Product Change Notification

PCN-PCC-7333-2021

Business Unit	Product Line Code	Type of Change	Action	Date of Issue
PCC - PCB Connectors	AAA	Product Change Notification	Notify Distributors and Field	10/25/2021

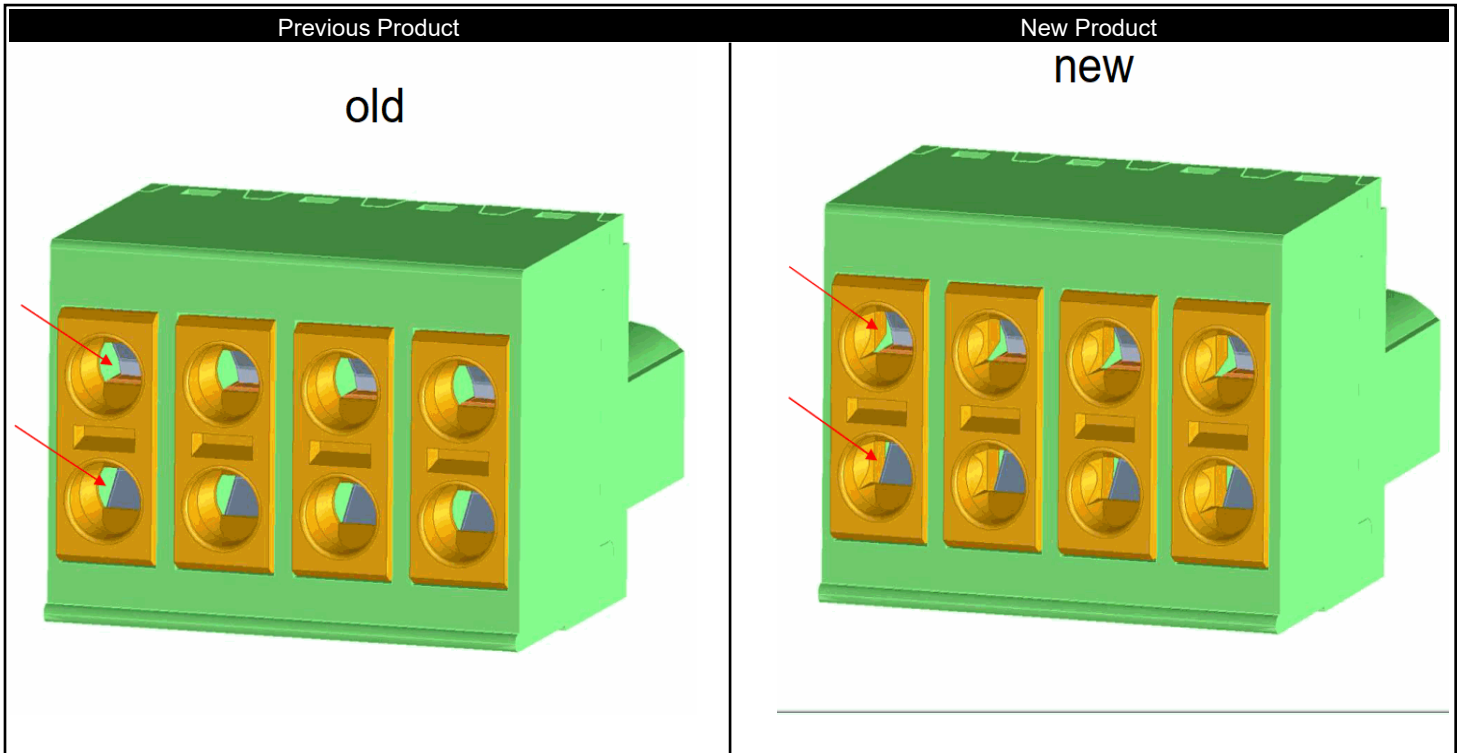
To optimize conductor routing in the cable entry funnel, the spring levers have locating tabs on the side. They are barely visible from the outside and, in the attached image, arrows indicate the "old-new" comparison. The external dimensions, conductor connection capacity, and electrical data remain unchanged. The effective date for this change is May 1st, 2022.
